City of El Paso – City Plan Commission Staff Report

Case No:	SUSC13-00006 Montecillo Unit Six
Application Type:	Major Preliminary
CPC Hearing Date:	January 09, 2014
Staff Planner:	Nelson Ortiz, (915) 541-4931, ortiznx@elpasotexas.gov
Location:	West of Mesa and South of Carousel
Acreage:	15.749 acres
Rep District:	8
Existing Use:	Vacant
Existing Zoning:	SCZ (Smartcode; T1, T3, T4, T4O)
Proposed Zoning:	SCZ (Smartcode; T1, T3, T4, T4O)
Nearest Park:	Playground proposed within subdivision
Nearest School:	Morehead Middle School (.59 mile)
Park Fees Required:	N/A
Impact Fee Area:	N/A
Property Owner:	EPT Mesa Development East, L.P.
Applicant:	EPT Mesa Development East, L.P.
Representative:	Conde, Inc.

ATTACHMENT 3

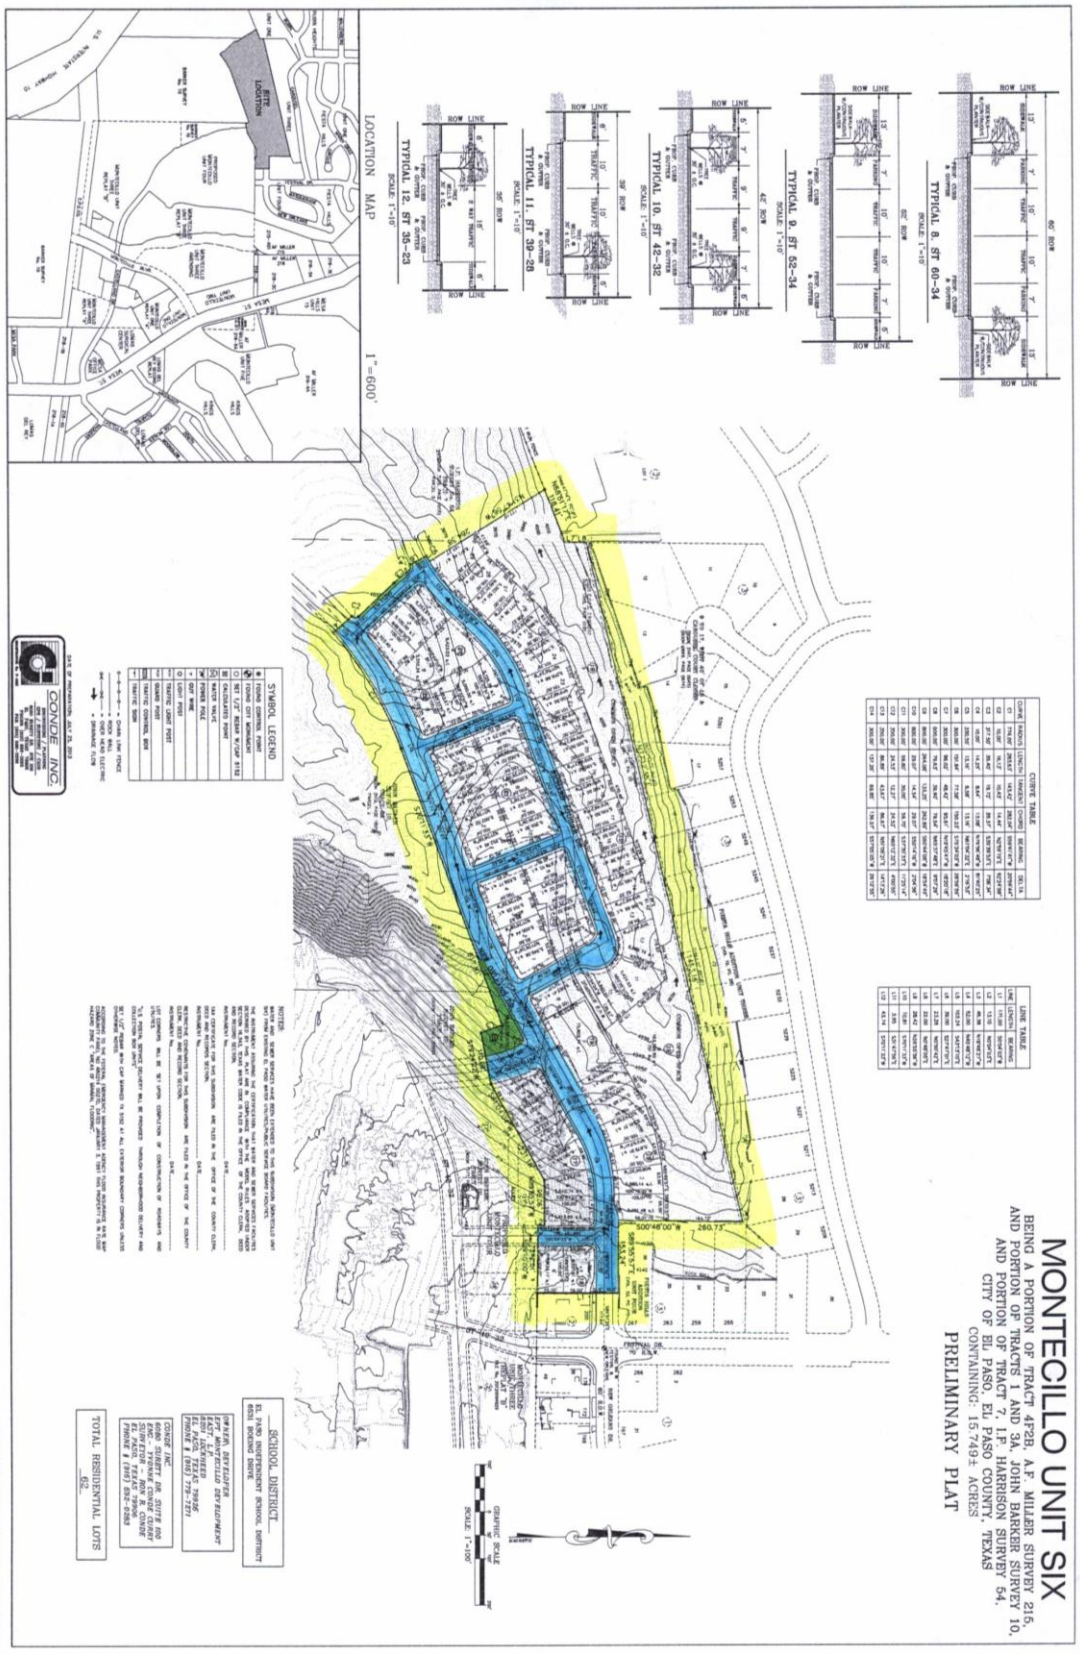
1. Show the drainage flow for the alley and the drainage right-of-way.
2. The stormwater seem to flow outside of this Plat; the developer shall be responsible for maintenance of all offsite stormwater management facilities unless drainage easements or rights-of-way with adequate access are provided for the EPWU Stormwater Utility.

1. Playground area: Lot 1, Block 23
    a) Per meeting discussions, applicant has offered to enlarge the boundary limits large enough to accommodate at least a 50'x50' area for the playground structure.
    b) Parks requests that during the playground area design, a 4'- 6' high safety fence be introduced all along the entire boundary line due to the close proximity of the proposed playground area to the street and the hazards of the road traffic to prevent a child from inadvertently running into the traffic or steep slopes (nearby hazards) as per The Consumer Product Safety Commission (CPSC) standards.

1. Areas noted as "Common Open Space" (Lot 9, Block 19) shall be cleaned and free of trash & all manmade sloped / disturbed areas shall be re-vegetated with desert plants

1. *The EPWU cannot commit to provide sewer service at this time.*
2. *Sanitary sewer service to the subject development is critical*
3. *EPWU has reviewed preliminary sewer designs from the Owner/Developer's Engineer. EPWU has identified several segments of the preliminary designs which present inadequacies such insufficient main cover, excessive depths of the mains. EPWU respectfully requests further information and further coordination prior to EPWU agreement to provide service.*

Addressing shall be displayed on the plat.
